<b>Product(s):</b>	<b>Fabius GS</b>
<b>Bulletin Number:</b>	<b>129</b>
<b>Release Date:</b>	<b>January 31, 2002</b>
<b>Pages:</b>	<b>8</b>

## **Subject: Fabius GS Software Version 1.20 (Upgrade)**

This document compares the old Fabius GS software 1.12 with our new software 1.20.

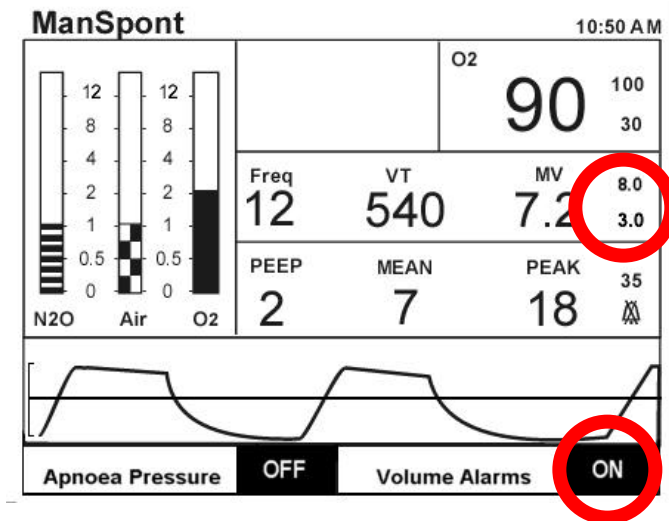
2. In 1.12 switching the "Volume Alarm" to "On" or "Off" in Man/Spont mode is accomplished by indicating the next state of the alarm over the respective softkey. When the alarm is off the 'label' reads "On". When the alarm is on the label reads "Off"

In 1.20 the label over the softkey indicates the current state of the alarms. When the alarms are on the label will read "On". When the alarms are off the label will read "Off".

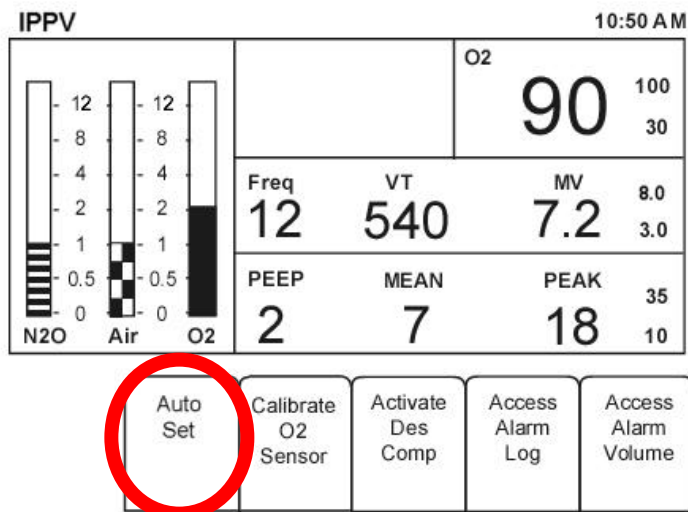
- In 1.12 there is no autoset feature for the breathing pressure threshold setting.

In 1.20 an autoset softkey is added to the Volume, Pressure, and Man/Spont menu screens. Pressing the softkey sets the threshold to four cmH2O below the current Peak pressure data value but the threshold setting may not be less than five or greater than thirty. In the absence of a current Peak pressure data value pressing the softkey will have no effect. A Threshold Low alarm is added with this change. Vitalink and Medibus outputs support this new feature.

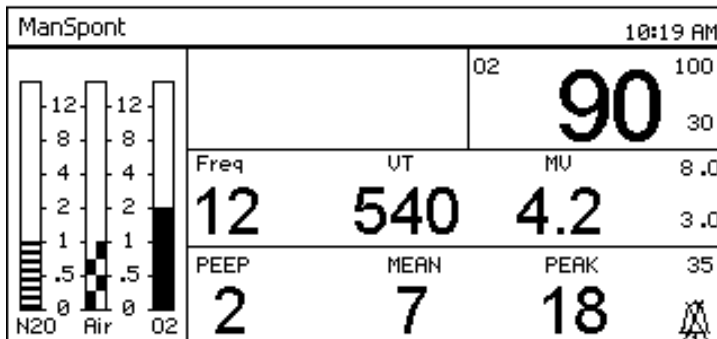
- In 1.12 the Standby mode confirm screen message relating to turning off gasses is in a small font.

In 1.20 the message is in a more noticeable font.

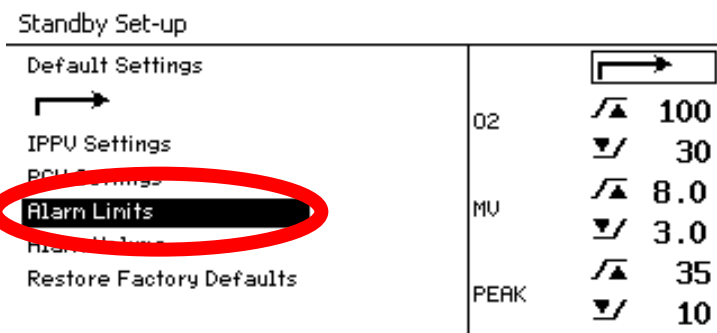
7. In 1.12 the Standby menu has an “Alarms” selection label under defaults.

In 1.20 this selection label is changed to “Alarm Limits”.

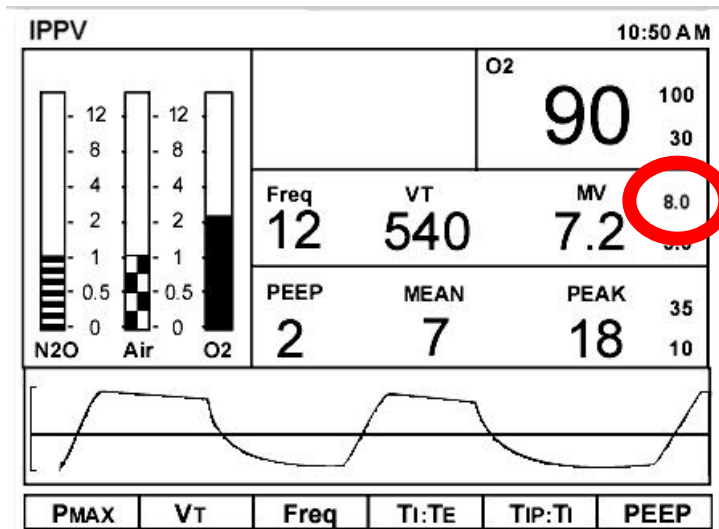
8. In 1.12 there is no Minute Volume high alarm.

In 1.20 there is a Minute Volume high alarm limit setting in the alarm limits screen, the alarm limits default screen, and in factory default settings. The range of this setting is 0.1 to 20.0 l/min but not less than the Minute Volume low alarm limit. When the high alarm limit is exceeded a medium priority alarm is annunciated. Vitalink output supports this new feature.

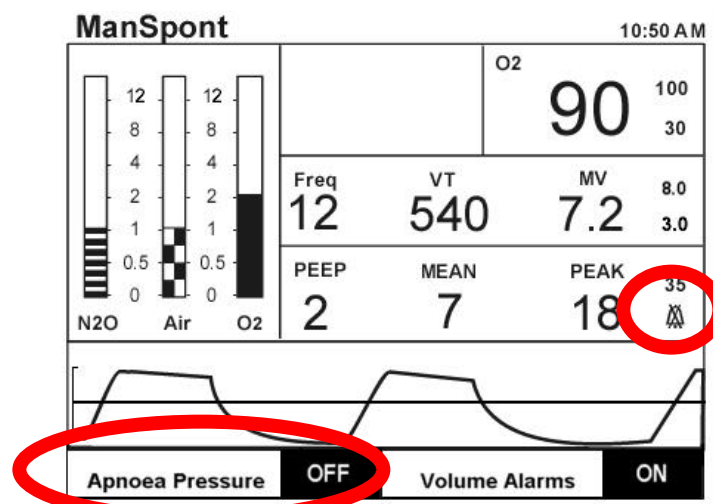
10. In 1.12 there is no provision for enabling the pressure apnea alarm while in Man/Spont.

In 1.20 there is a softkey similar to the volume alarms key to turn the "Pressure Apnea Alarm" on and off.

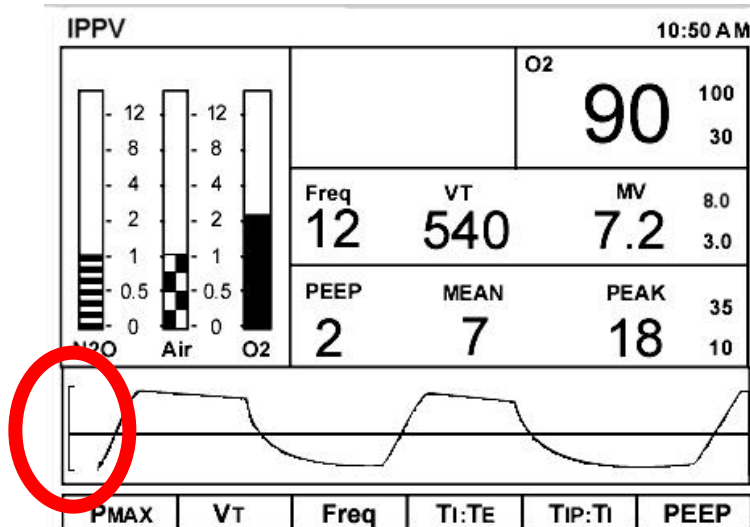
12. In 1.12 there is no indication of where the minimum and maximum vertical limits are for the active trace area of the pressure waveform.

In 1.20 there is an indicator that marks the minimum and maximum vertical limits for the pressure waveform.

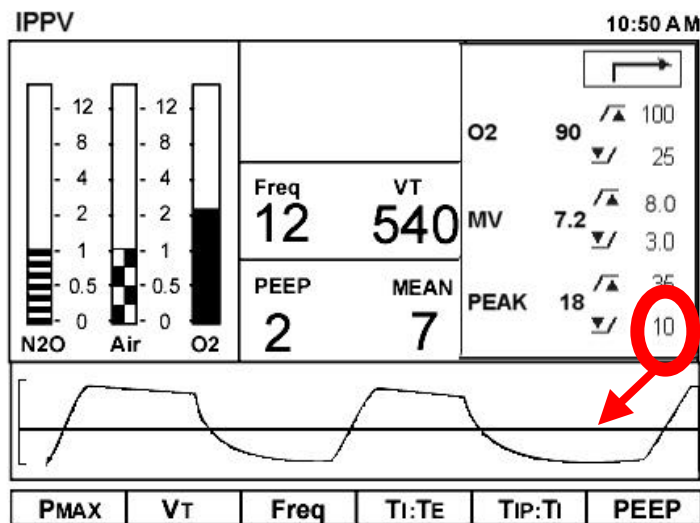
13. In 1.12 the graphic threshold setting indicator does not change until a new numeric setting is confirmed.

In 1.20 the graphic threshold setting indicator changes as the numeric setting is changed. If the numeric setting is not confirmed, the graphic indicator reverts to the previously confirmed setting.

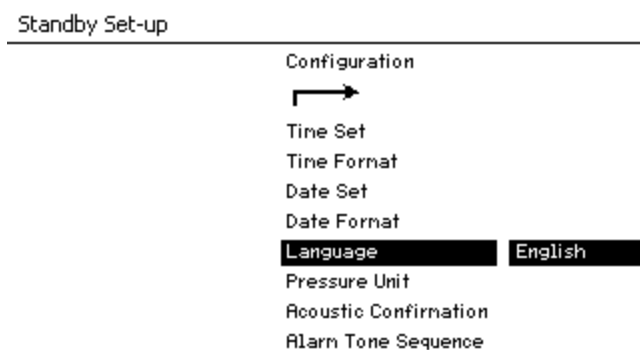
17. In 1.12 confirming a new language setting does not immediately change all the labels in the Standby menu screen.

In 1.20 confirming a new language immediately changes all the labels in the Standby Menu screen.

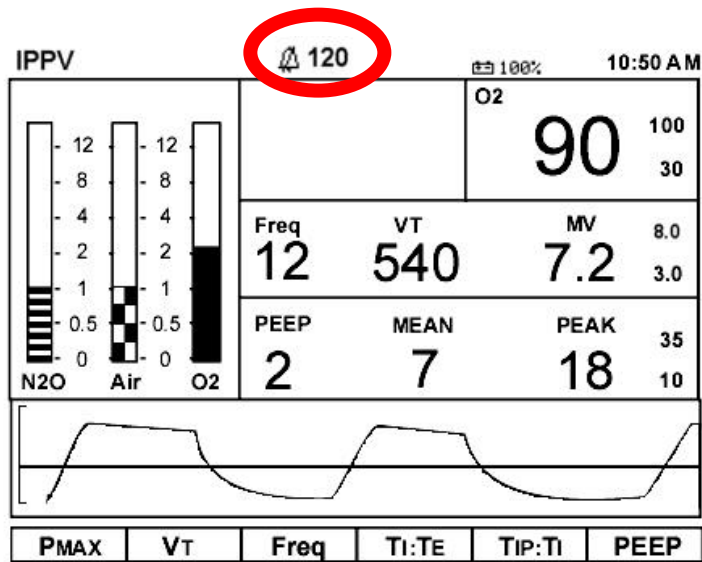
18. In 1.12 the audio silence counter does not count down to zero.

In 1.20 the audio silence counter counts down to zero
